SUBJECT: Forwards responses to draft SER Open Items 103, 106, 116, 118, 119, & 153.

SHEARON HARRIS NUCLEAR POWER PLANT
UNIT NOS. 1 AND 2
DOCKET NOS. 50-400 AND 50-401
DRAFT SAFETY EVALUATION REPORT RESPONSES
POWER SYSTEMS BRANCH

Shearon Harris Nuclear Power Plant
Draft SER Open Item No. 103
(FSAR Section 8.3, NRC Question 430.13)

NORMAL/EMERGENCY (N/E) AC LIGHTING
(SEE NOTE 1)

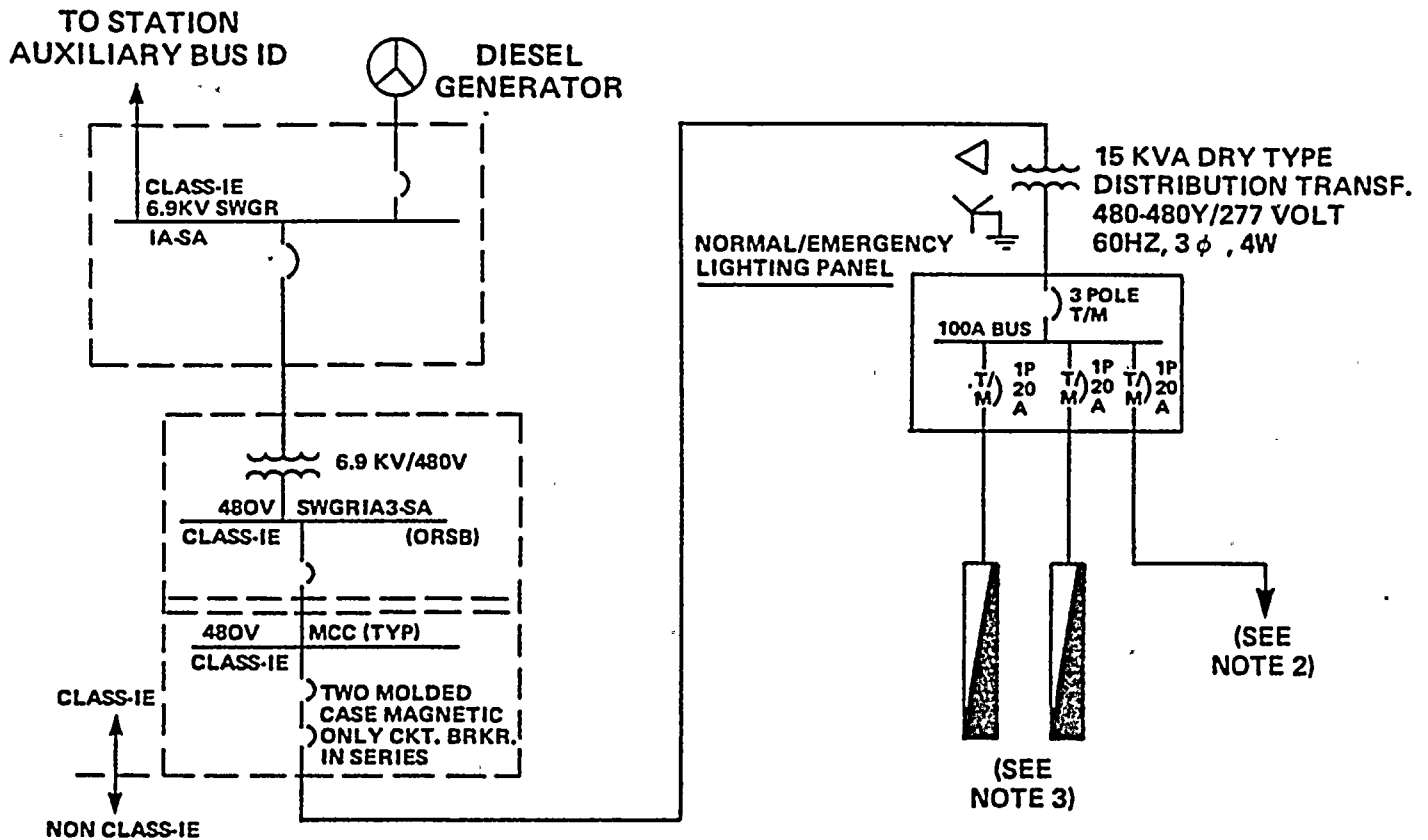
Provide a more detailed and complete description of the plant emergency lighting system to include identification of areas covered, devices used, and system power diversity. Include in the description the provisions provided for adequate lighting for the control room and in particular during switchover from normal to emergency power assuming a single active failure of a Diesel Generator.

The normal/emergency AC lighting normally receives power from the station safety related auxiliary power system through the unit auxiliary transformers or start-up transformer. In the event of the loss of offsite power, the power to the lighting system is provided from the onsite diesel generators. This design precludes the complete loss of lighting in the control room and other vital areas due to a single failure in any one of the safety divisions of its associated diesel generator. The attached Figure 106-1 identifies the various devices utilized for the normal/emergency AC lighting.

FUEL OIL PIPING SCHEMATIC
FIGURE 9.5.4.2

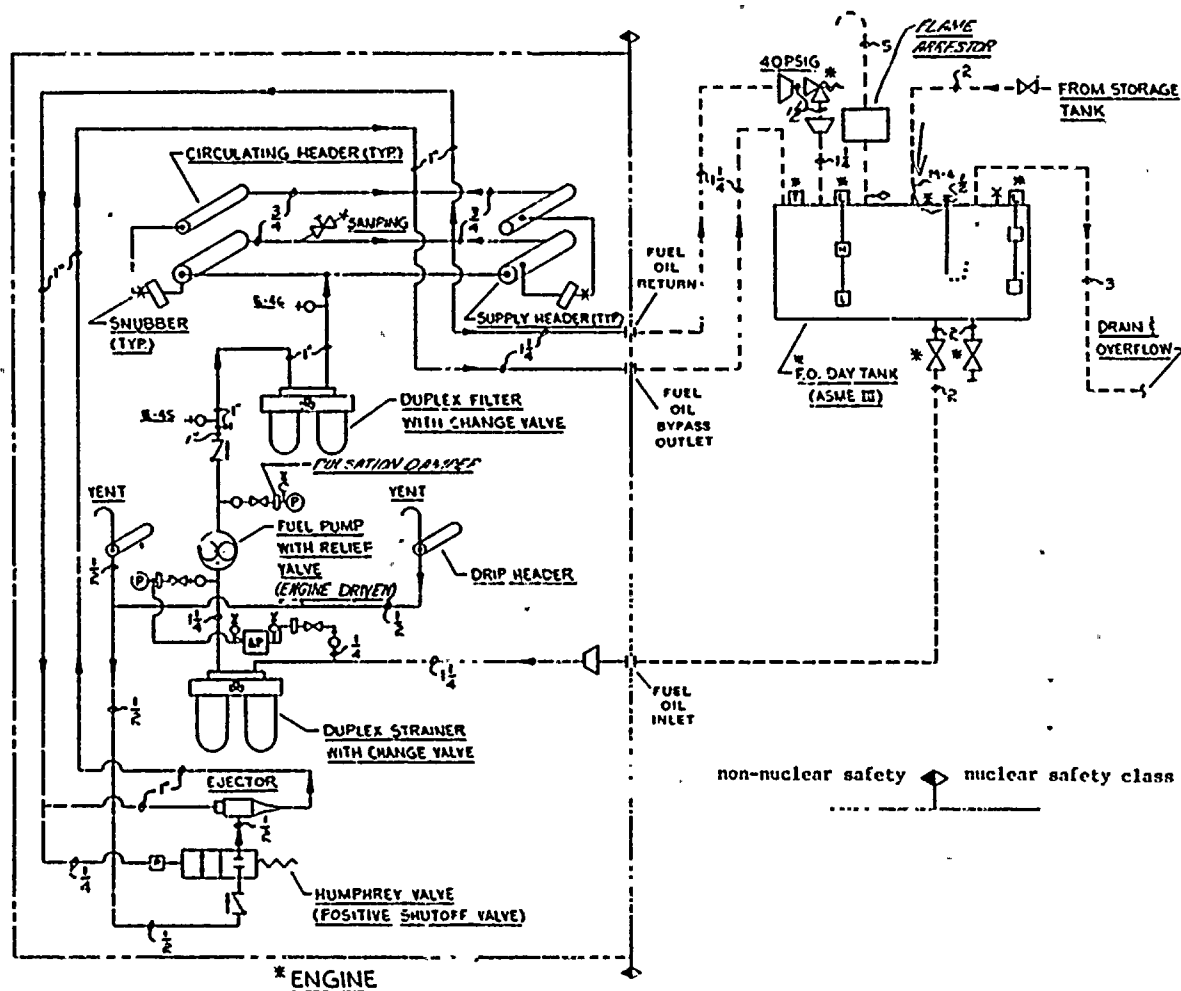
A more detailed discussion is required than that provided in the NRC Question 430.36 response regarding component safety class. This information should also be identified on Figure 9.5.5-2.

The diesel engine mounted piping and components consisting of an engine driven fuel oil pump, a duplex filter, a duplex strainer, an ejector system, an injector system, manifolds and valves (check, shut-off and relief valves), is shown in detail on the attached Figure 9.5.4-2. Pressure and level switches and gauges are provided for alarm, control, and indication.

Upon receipt of a signal initiating diesel start, the diesel engine shaft driven fuel pump takes suction from its associated day tank through a duplex strainer and discharges fuel oil to the diesel engine through a check valve and duplex filter. A relief valve is provided to protect the system.

Leaving the duplex filter, fuel oil flows to the supply header and circulating header. Fuel oil is then fed to each cylinder fuel injector. The governor controls the fuel racks which in turn regulates the amount of fuel oil injected to the cylinders, thus controlling the engine speed. Since the fuel oil pump is sized (26 GPM) to pump more than the engine needs, fuel oil not used by the injectors is returned to the day tank by means of an ejector system. The ejector system regulation is controlled by a pressure regulator which is mounted on the day tank. Also mounted on the day tank are level indicators to annunciate low and high level in the tank. A flame arrestor is incorporated on the tank vent to protect the tank from fire.

The Diesel Generator Fuel Oil System (excluding the engine mounted piping and components) is designed in accordance with Seismic Category I and ASME Boiler and Pressure Vessel Section III Code Class 3, as indicated in FSAR Table 3.2.1-1. The engine and fuel oil system piping and components on the engine meet the guidelines as stated by the DEMA standards. The design stresses which include mechanical, pressure and thermal, and seismic induced loads for the engine mounted piping have been determined by the Diesel Generator manufacturer, Transamerica DeLaval Incorporated (TDI), to be well within the allowable stresses as permitted by ANSI B31.1.
